PITTSFIELD TOWNSHIP PLANNING COMMISSION AGENDA

Monarch Estates

Project:
CSPA 19-17

PITTSFIELD TOWNSHIP, WASHTENAW COUNTY, MICHIGAN
 SINGLE-FAMILY RESIDENTIAL SITE CONDOMINIUM
 PHASE I FINAL SITE PLANS

SE MICHIGAN LAND HOLDINGS LLC
MONARCH ESTATES
PHASE I FINAL SITE PLAN
INTERSECTION PLAN

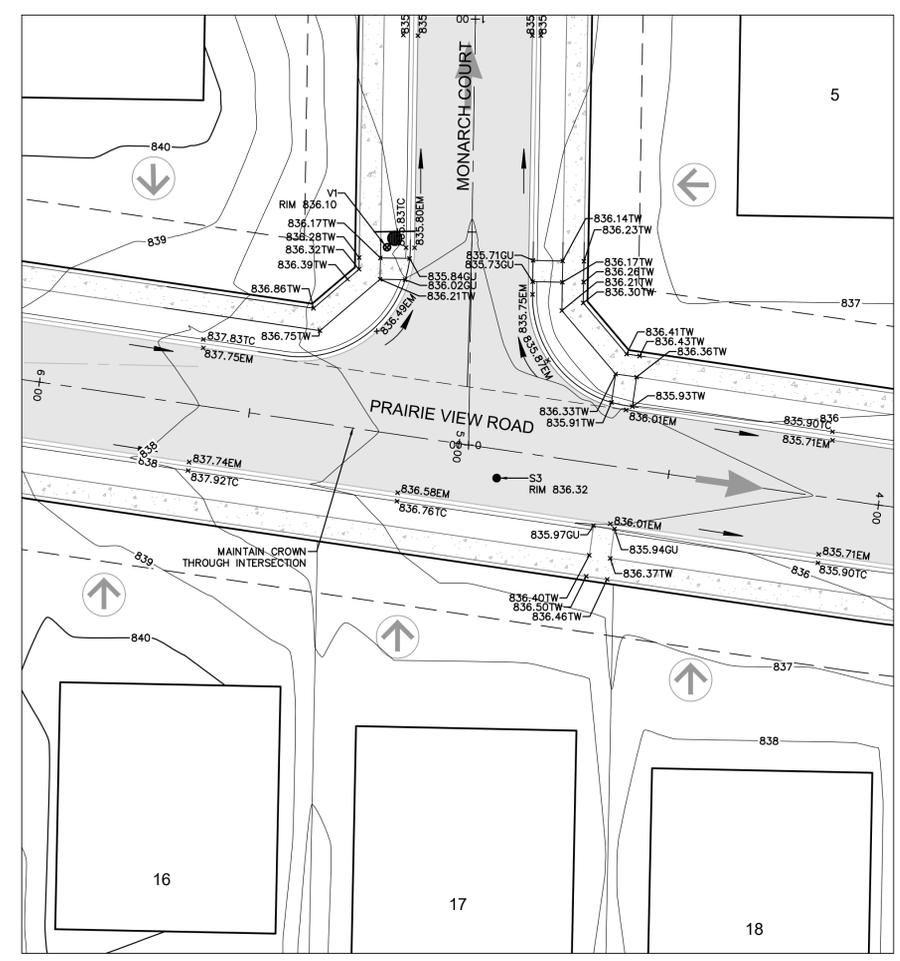
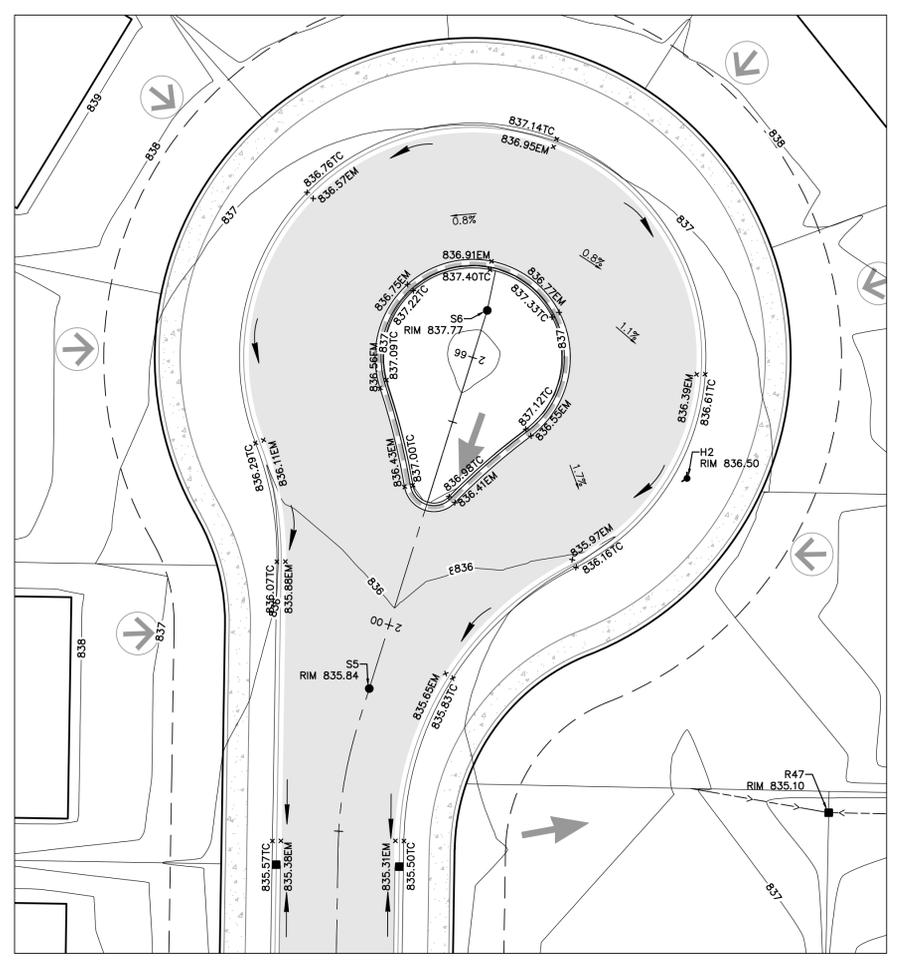
6. Sheet 8; Intersection Plan
 - a. The maximum sidewalk slope for ADA compliance is 2% on cross slope and 8.3% on downslopes. It is recommended that the sidewalk slopes are designed at approximately 1.5% and 7.5%, respectively, to allow for construction variations.

SE MICHIGAN LAND HOLDINGS LLC
MONARCH ESTATES
PHASE 1 FINAL SITE PLAN
KOCH-WARNER DRAIN
PLAN & PROFILE

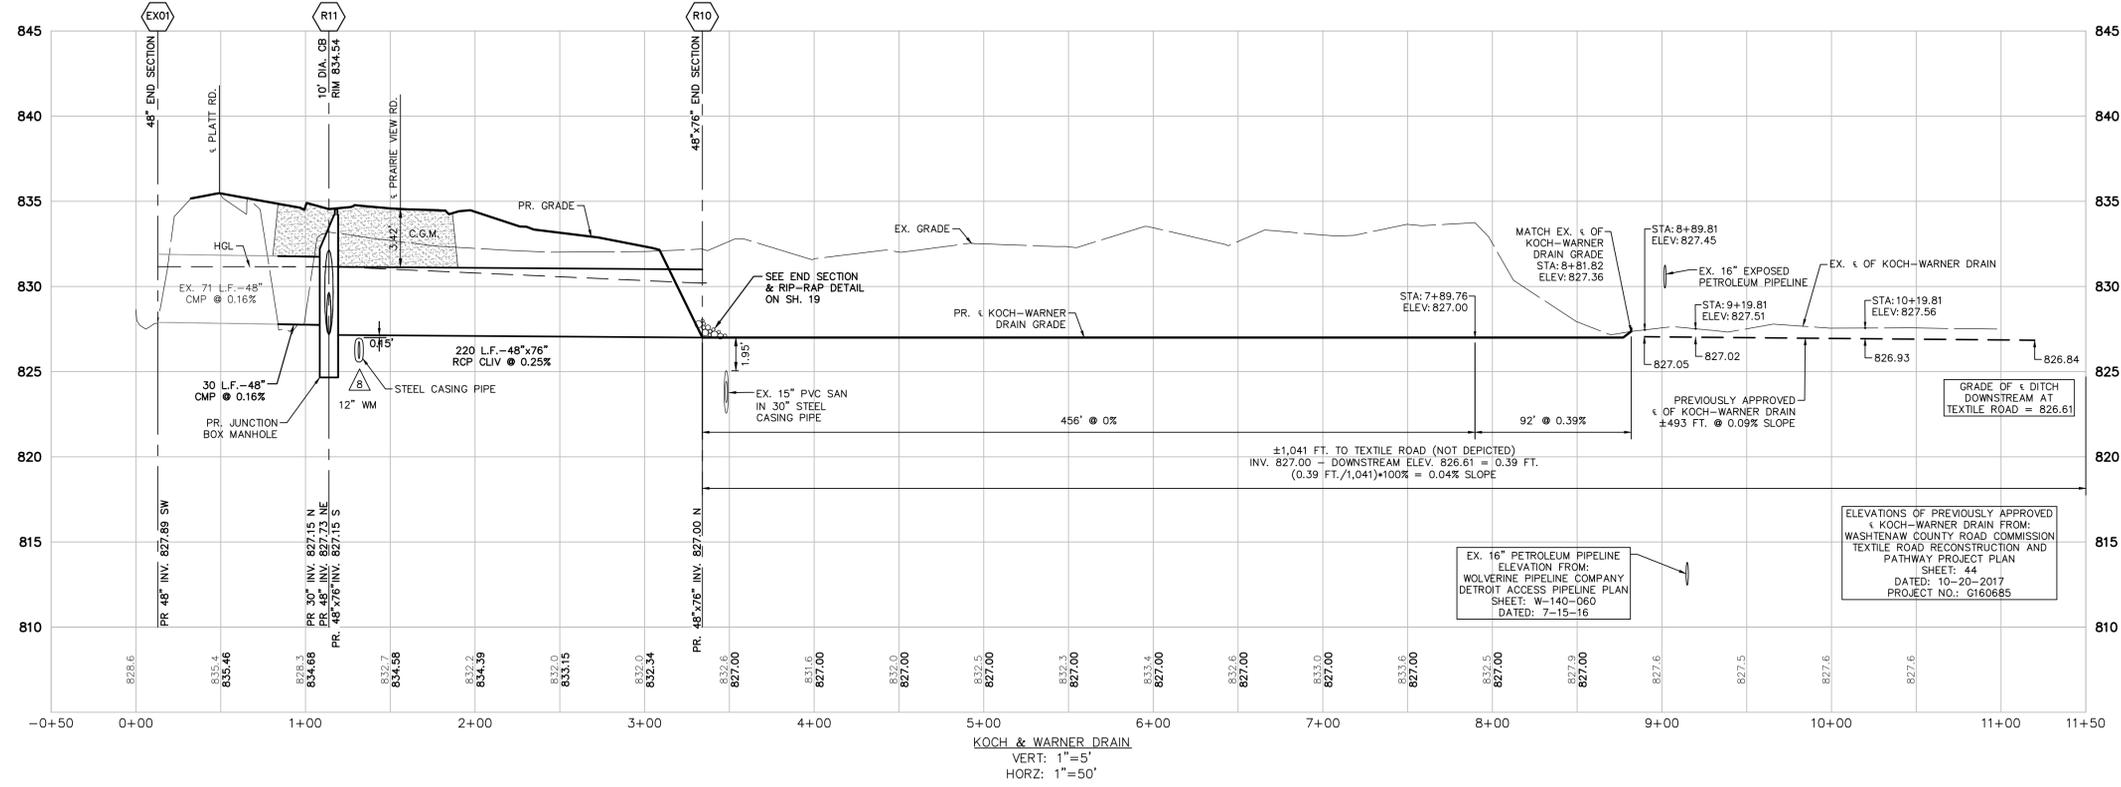
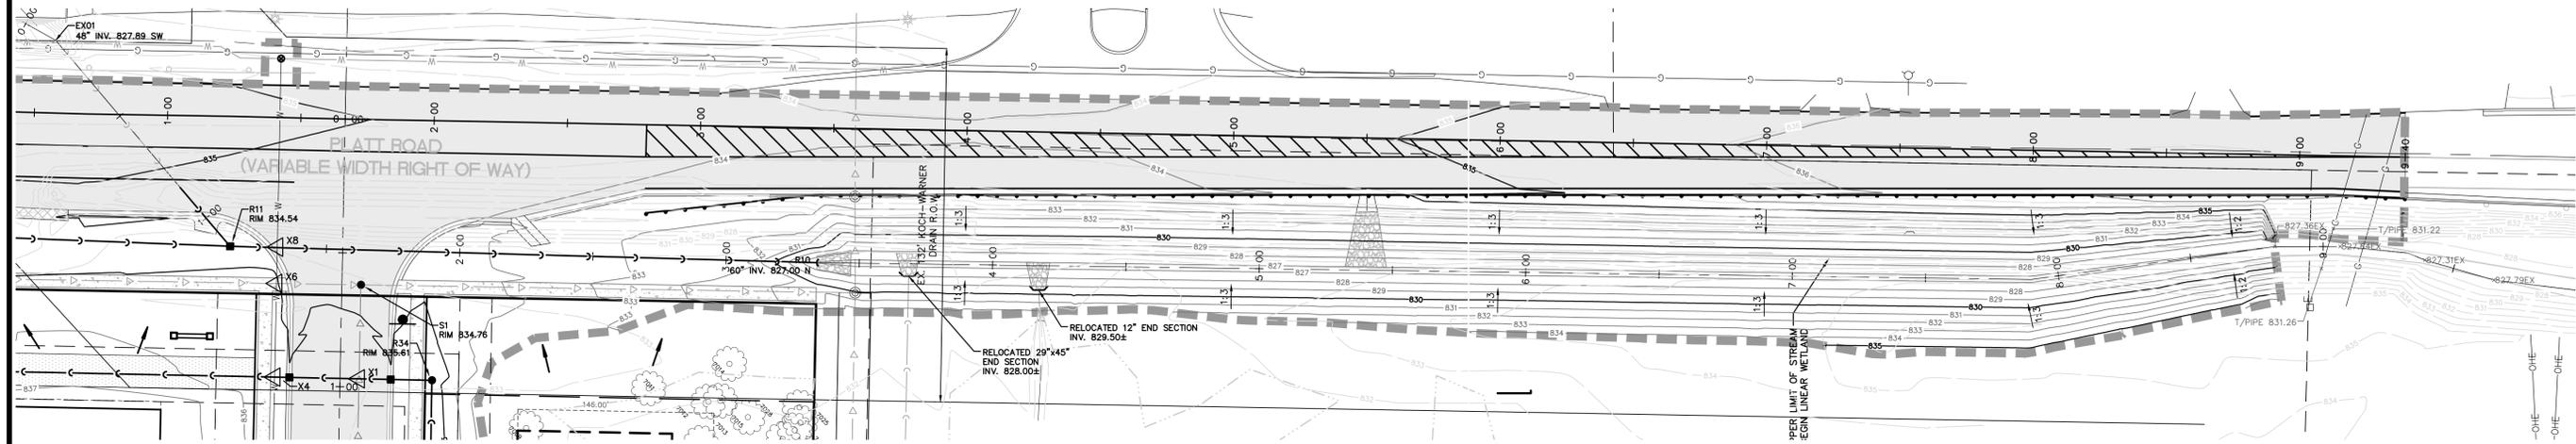
7. Sheet 11; Koch-Warner Drain Plan & Profile
 - a. Rip rap shall be proposed at the three end sections draining water into the re-graded Koch-Warner Drain.
